Norfolk Boreas Offshore Wind Farm

Statement of Common Ground

Natural England

Applicant: Norfolk Boreas Limited
Document Reference: ExA.SoCG-17.D10.V4
Deadline: 10
Date: May 2020
Revision: Version 4
Author: Royal HaskoningDHV

Figure 1 *Sabellaria spinulosa* reef mapping by the Applicant and Natural England

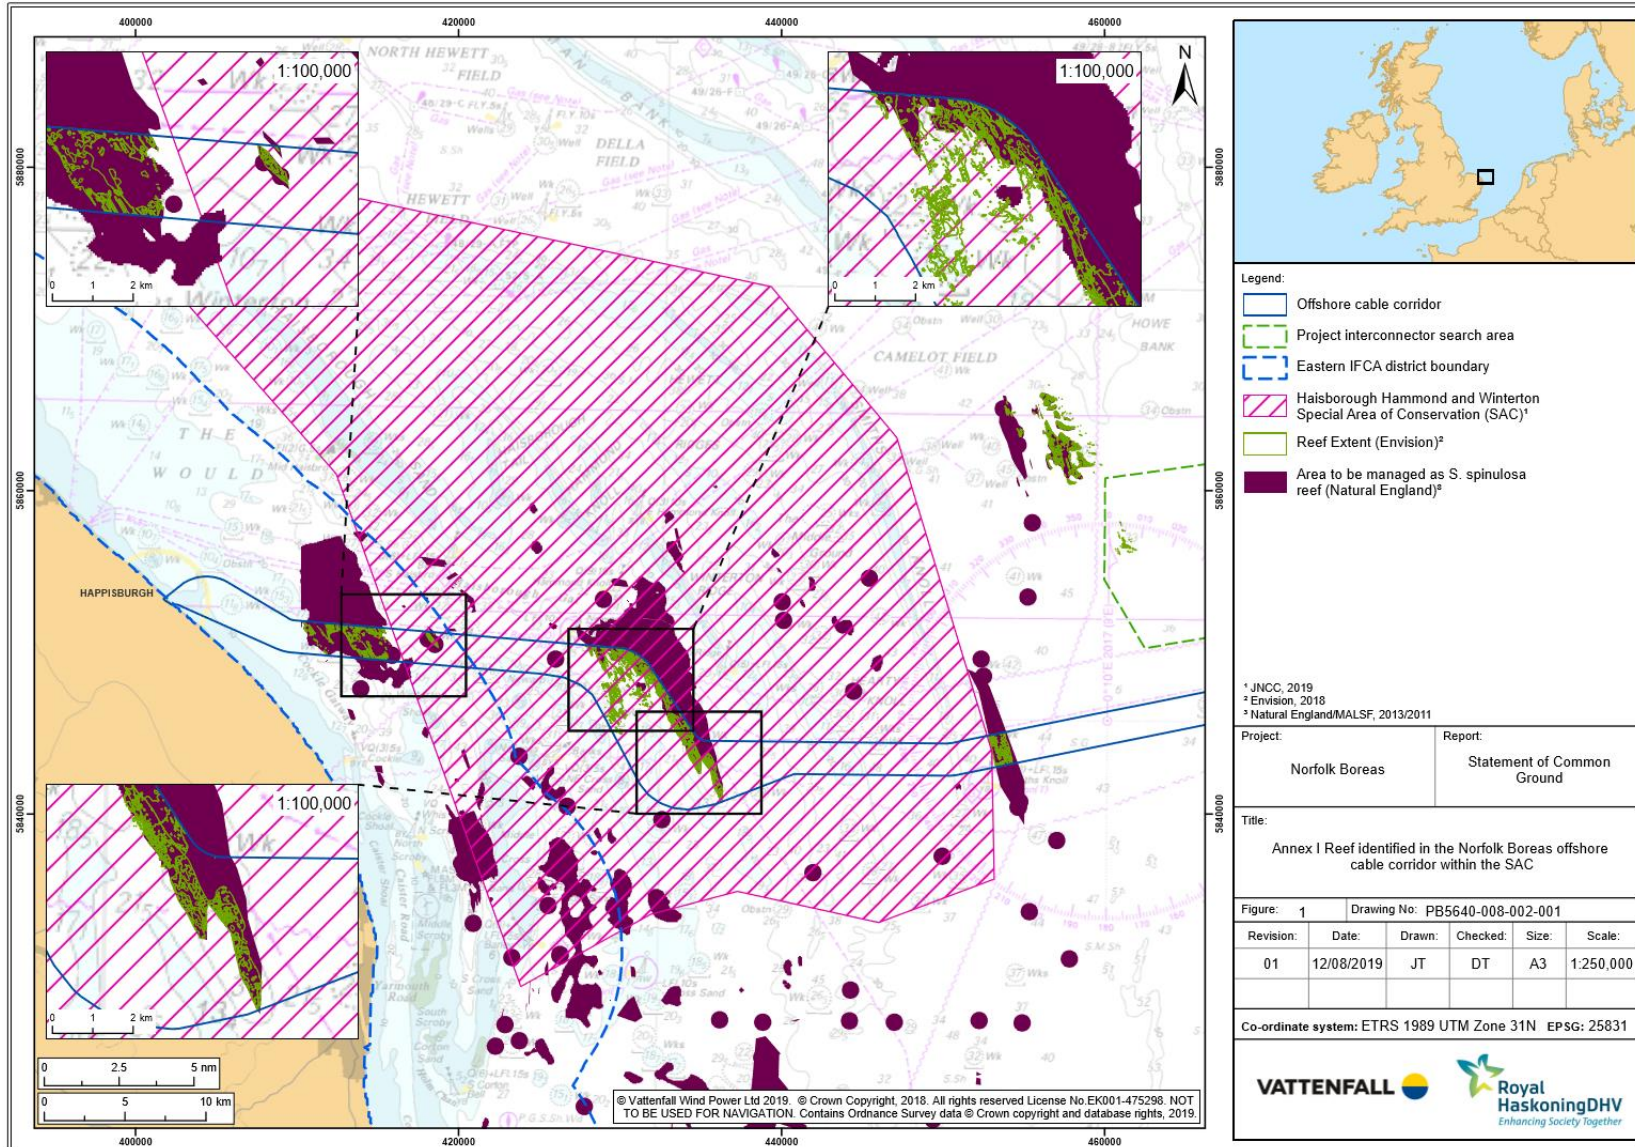
Topic	Norfolk Boreas Limited position	Natural England position	Final position
Site Selection and Project Design			
Landfall	Landfall at Happisburgh avoids impacts on the Cromer Shoal Chalk Beds MCZ	Agreed	It is agreed by both parties that landfall at Happisburgh avoids impacts on the Cromer Shoal Chalk Beds MCZ
Environmental Impact Assessment			
Existing Environment	Survey data collected for Norfolk Boreas for the characterisation of Benthic and Intertidal Ecology are suitable for the assessment as agreed in the survey planning meeting in March 2016 and the expert topic group meeting in March 2018.	Agreed	Agreed
	<p>The ES adequately characterises the baseline environment in terms of Benthic and Intertidal Ecology.</p> <p>For the purposes of the EIA, the site characterisation has identified the potential extent and location of <i>S. spinulosa</i> reef as far as reasonably practicable. This has allowed the EIA to assess potential impacts on <i>Sabellaria</i> reef.</p> <p>The assessment does not discount “low reef”. Figure 7.2 of the Information to Support HRA report presents a map of potential <i>Sabellaria</i> reef extent based on medium to high confidence of reef presence (N.B. this includes reef of any reefiness characteristic, including low). <i>Sabellaria</i> reef identified during the Norfolk Boreas benthic surveys in 2016 and 2017 was found to be of low or medium reefiness and this is included in the assessment.</p>	Agreed, although noting the uncertainty associated with <i>S. spinulosa</i> reef mapping due to the ephemeral nature of the reef, the analytical use of a range of datasets, and the confidence levels applied to reef presence	It is agreed by both parties that the ES adequately characterises the baseline environment in terms of Benthic and Intertidal Ecology, although noting the uncertainty associated with <i>S. spinulosa</i> reef mapping.

<p>The assessment does not discount "low reef" as stated in Natural England's relevant representation [RR-099]. It should be noted however that by definition, "low reef" is inherently patchy with only 10-20% coverage, Gubbay (2007) and therefore increases the potential for micro-siting. Medium reef also has high potential for micro-siting, being classified by 20-30% coverage.</p>	<p>Please see Natural England's advice on Applicant's clarification note on optimising cable routing through the HHW SAC [REP5-081] and Position Statement Regarding the Proposed Site Integrity Plan for the Haisborough Hammond and Winterton Special Area of Conservation [REP4-041]</p> <p>We continue to advise that low/patchy reef should not be micro-sited through i.e. avoided. Therefore, it</p>	<p>(D10) The approach to low reef is not agreed.</p>
